Approval of Reserved Matters Consultation

Application Number: 253142

Site Address: Parcels R7 and R13, Land at Phase 2b of the South Wokingham Strategic Development Location (SDL), Wokingham

Proposal: Reserved Matters pursuant to Outline Planning Consent 191068 comprising the erection of 215 dwellings and associated infrastructure with details of appearance, landscaping, layout and scale to be considered.

Access Width

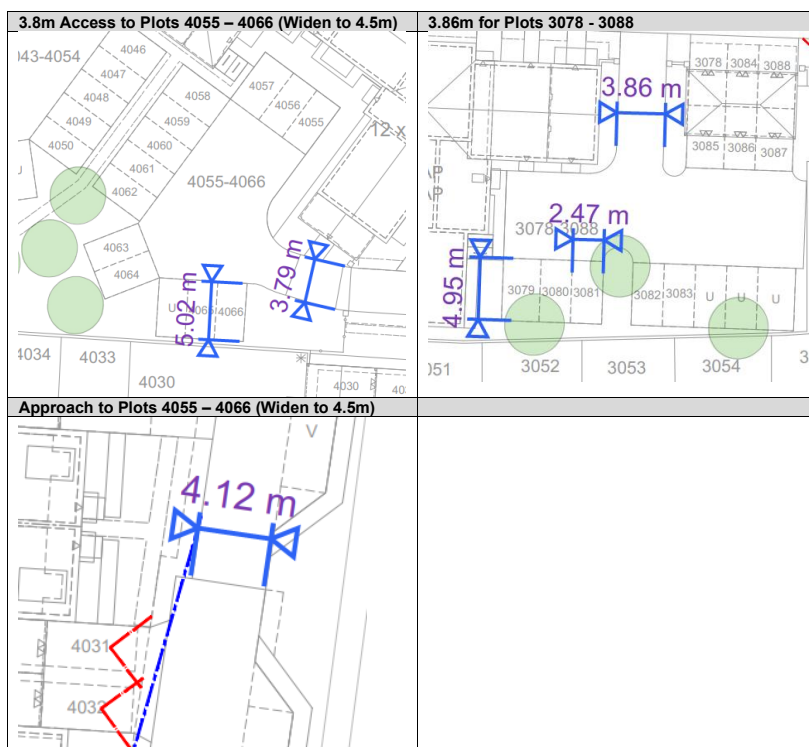
1. Several access widths will need to be improved from 3.8m to 4.5m in order to comply with the guidance in Wokingham Living Streets (2019) which identifies a minimum access width of 4.5m for access to Mews/Parking Courts with more than 10 dwellings. 3.8m will not be wide enough to allow two modern vehicles to pass each other, even at a slow speed. This could result in cars mounting the footway to pass each other, to the detriment of pedestrian safety.

2. A list of the most sold cars in 2025 and their dimensions is provided below. Cars measuring c.1.93m – 2.06m wide will not be able to pass each other on a 3.8m wide access.

- a) Screenshots are provided below of the areas where a wider access is required:

The above areas have been widened as part of the revised masterplan. See AAP Drawing P1905.R07.R13.01-G Proposed Planning Layout.

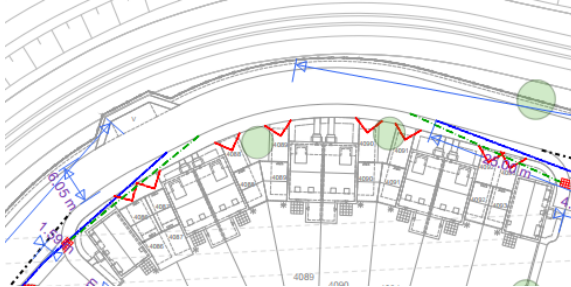
3. The LHA require the applicant to demonstrate forward visibility for vehicles around the bend shown below, which appears to have been omitted from the assessment of visibility on site.

ALP Drawing A389-R7&R13-PL-002 rev E illustrates forward visibility for vehicles around the bend.

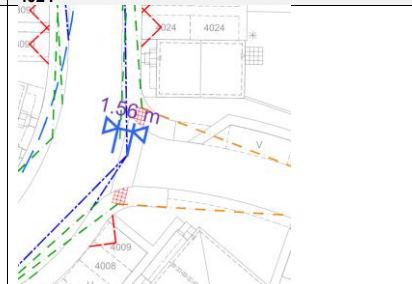
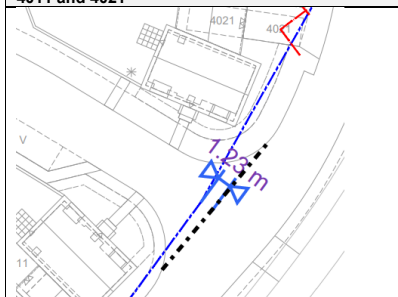
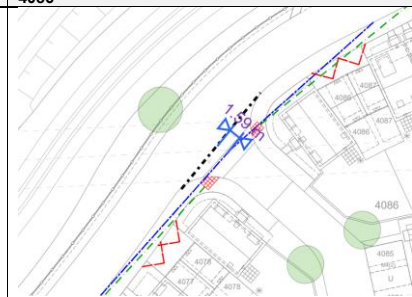
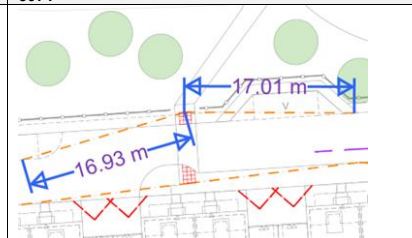
4. The LHA require remeasurement of several visibility splays which appear to be measured using an X distance of 1.8m – 2.0m instead of the minimum X distance of 2.4m specified in Manual for Streets.

- a) The LHA would welcome demarcation of stop lines on the visibility drawing so it is possible to assess where the X distance can be measured from.

5. Other visibility splays shown do not comply with the required Y distance of 25 metres. The Wokingham Living Streets Guidance (2019) requires a design speed of 20mph and Manual for Streets Table 7.1 requires a visibility splay of 2.4m x 25m on a road subject to a 20mph speed limit.

6. It is concerning that despite incorrect X and Y distance, there are still several visibility splays which pass through visitor parking bays or driveway parking bays. These bays are likely to pose a greater obstruction once the visibility splays have been correctly measured by the applicant. Some visitor bays will need to be relocated to prevent obstruction of visibility. The Manual for Streets Para 7.8.5 states that: *'Ideally defined parking bays should be provided outside the visibility splay'* and this is interpreted to mean that ideally parking bays should be outside the visibility splay where the developer is designing the site from scratch.

7. At the junction between Plots 3042 and 3051, an X distance of 1.8m appears to have been used by the consultant.

ALP Drawing A389-R7&R13-PL-002 rev E illustrates an x-distance of 2.4m is achieved at all junctions as well as including indicative stop lines to aid the review process.

Following revisions to the masterplan ALP Drawing A389-R7&R13-PL-002 rev E illustrates visibility splays of 2.4m x 25m throughout at all junctions and ALP Drawing A389-R7&R13-PL-007 rev C illustrates visibility splays of 25m at all crossing points.

Many of the original junctions did achieve a 2.4m x-distance, however, all the five junctions illustrated above and through the layout now achieve a 2.4m x-distance. See ALP Drawing A389-R7&R13-PL-002 rev E

The bottom two images of the pedestrian visibility have been addressed as a result of altering the masterplan and removing one of the visitor spaces, which was agreed at the post submission meeting on 02.03.2026. See ALP Drawing A389-R7&R13-PL-007 rev C.

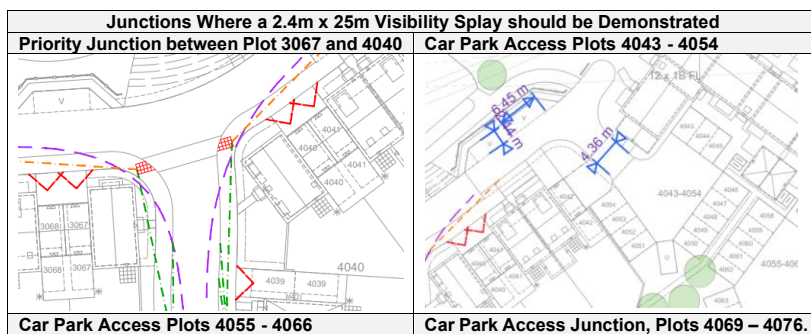
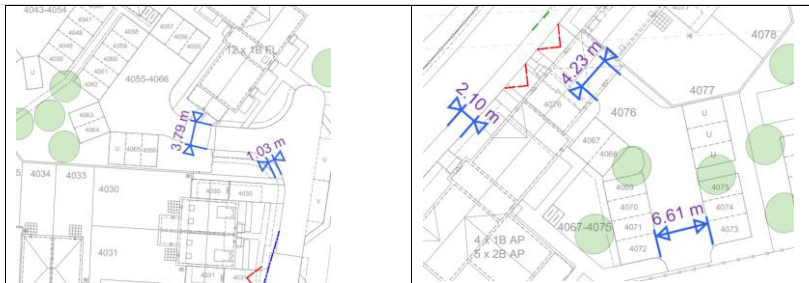
8. Several visibility splays appear to cross land which will fall within private ownership or front gardens of properties. The LHA request planning conditions and covenants which restricts planting to a height of 600mm within these visibility splays.

Noted

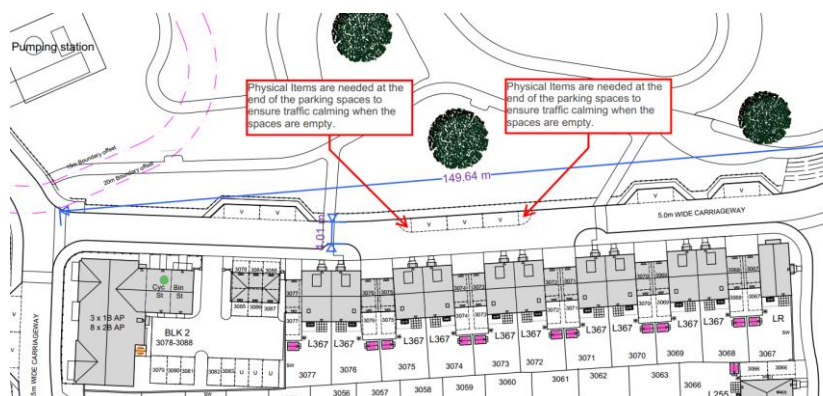
9. Visibility splays have not been shown at several junctions or accesses to several car parks. The LHA require visibility splays to be shown at the following junctions:

- The proposed priority junction between plot 3067 and plot 4040;
- The vehicle access to the car park for Plots 4043 – 4054;
- The vehicle access to the car park for Plots 4055 – 4066;
- The vehicle access to the car parking area for Plots 4069 – 4076; and
- The crossover access to plot 4105 and the pumping station opposite.

10. Screenshots of the junctions/accesses where visibility splays need to be demonstrated are shown below:

These are now shown in ALP Drawing A389-R7&R13-PL-002 rev E.

Visibilities added in ALP Drawing A389-R7&R13-PL-002 rev E.

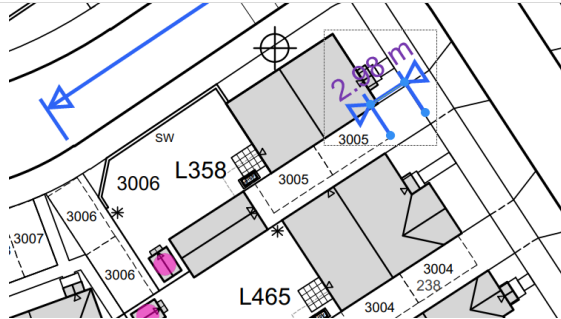
11. Car parking bays appear to have been used as traffic calming features. There should be physical features at each end of the parking bays to ensure speed reduction still occurs when the spaces are empty and to ensure vehicles to not just treat the empty spaces as part of the carriageway. Otherwise, there is an almost straight road c.150m long.

It was discussed and agreed during the post submission meeting on 02.03.2026 that kerbing would be introduced at each end of the visitor parking to slow vehicles through this section of the layout if no cars were parked in the visitor spaces.

Crossing Detail Appears Inconsistent with other drawings	Crossing Detail Appears Inconsistent with other drawings

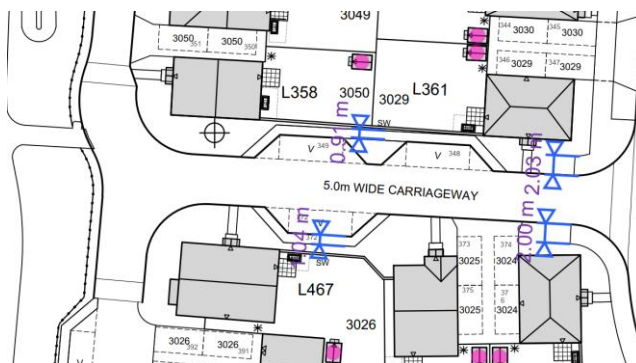
d.c. A pedestrian path joins the carriageway in the middle of a priority junction between Plots 3050 and 3026. A formal crossing point should be provided to the footway with dropped kerbs and tactile paving provided. Ped visibility of vehicles should be demonstrated with a 25m Y distance.

f.d. The plans do not consistently show a crossing outside Plot 3042. Some plans show the path crossing in the middle of a priority junction which is not considered acceptable.

Crossing between Plots 3026 and 3050. Relocate north or south away from junction.

The connecting path to the R13 perimeter informal footpath has been move south of the junction where it joins the shared surface to the north of a private drive serving parking for 3 houses. A crossing is subsequently not required.

All drawings now consistently show the crossing to the south of the junction as illustrated in ALP Drawing A389-R7&R13-PL-007 rev C. Also see ALP Drawing A389-R7&R13-RM-701 rev B.
